SUSQUEHANNA STEAM ELECTRIC STATION
REVISED RESPONSE TO COMMON REACTOR VESSEL LEVEL
INSTRUMENTATION REFERENCE - SER OPEN ITEM NO. 99.
ER100450 FILE 841-2, -12
PLA-797

This letter provides a revised response to NUREG-0737, requirement II.K.3.27. This response completes our action and will allow closeout of open item no. 99.

SUBJECT: PP&L APPEAL OF THE NRC STAFF POSITION REGARDING LOW PRESSURE
CONTAINMENT LEAKAGE TEST FREQUENCY

Attachment C

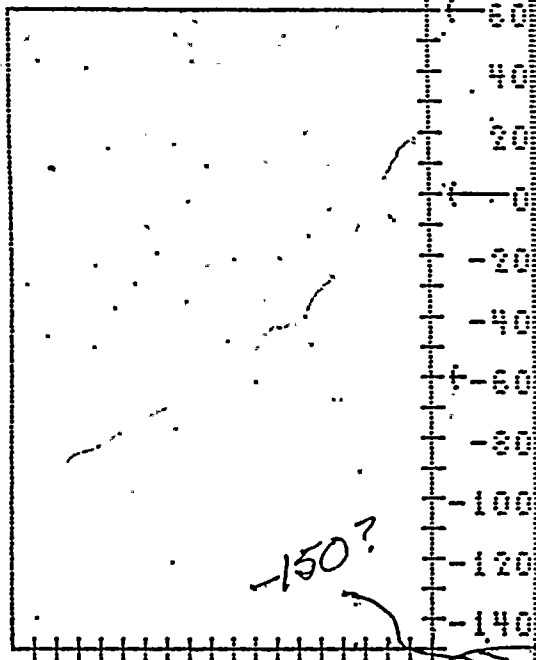
The second action being taken by PP&L is also designed to provide the operator with both an understanding of the meaning of the reactor vessel water level information and the relationship between that level and certain key points in the vessel. This is being accomplished by a

computer driven CRT color display, a black and white sample of which is given in attachment C. This display will provide the operator with a dynamic representation of level and, as part of the display, a twenty-minute trend of level.
